[Docket No. FAA-2012-1330; Directorate Identifier 2012-CE-006-AD; Amendment 39-17470; AD 2013-11-10]

Airworthiness Directives; Cessna Aircraft Company Airplanes

ACTION: Final rule.

Figure 2 of paragraph (g)(2)

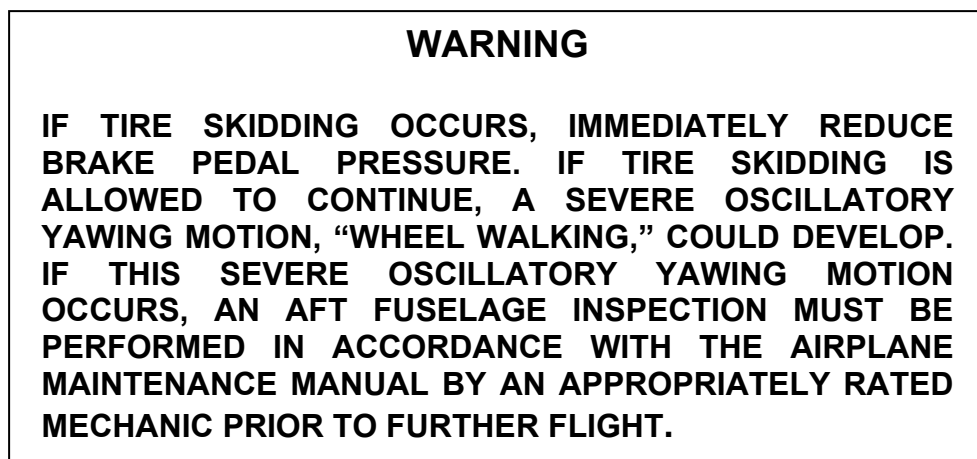
(2) Within the next 50 hours TIS after [INSERT DATE 35 DAYS AFTER DATE OF PUBLICATION IN THE FEDERAL REGISTER] (the effective date of this AD) or within the next 3 months after [INSERT DATE 35 DAYS AFTER DATE OF PUBLICATION IN THE FEDERAL REGISTER] (the effective date of this AD),

whichever occurs first, insert a copy of this AD into the POH/AFM or incorporate figure 2 of paragraph (g)(2) of this AD into the applicable POH/AFM at the end of each of the following sections:

- (i) Section 4, Normal Procedures (Amplified Procedures): Landings, Normal Landings; and
- (ii) Section 4, end of paragraph: Short Field Landings.
